TECHNICAL BULLETIN

GOT-A-0255-A

LCD (Display Device) Change for GT2103 Models and the Corresponding GT Designer3 (GOT2000) Versions

3 How to check the hardware version

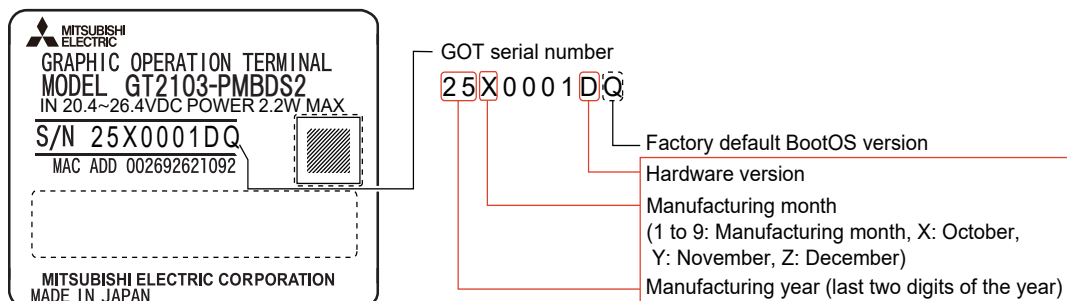
The hardware version and the manufacturing month and year can be checked on the rating plate located on the GOT rear face.
